UNITED STATES PATENT AND TRADEMARK OFFICE

Office Action Summary	Application No. 10/569,848	Applicant(s) TAKAGI ET AL.
	Examiner Nuri Boran ALTUN	Art Unit 3657

DETAILED ACTION

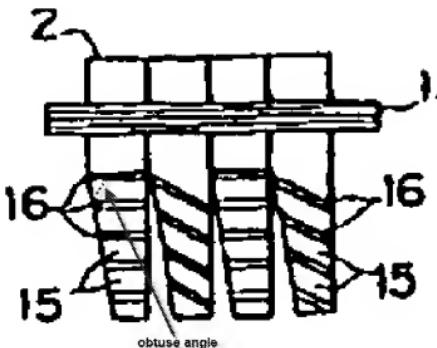
Applicant also argues, "Kato does not teach front portion of the contact surface forming an obtuse angle with a front surface of the push block." The examiner notes that, in the figure below, the front portion of the contact surface shows an obtuse angle with a front surface of the push block.
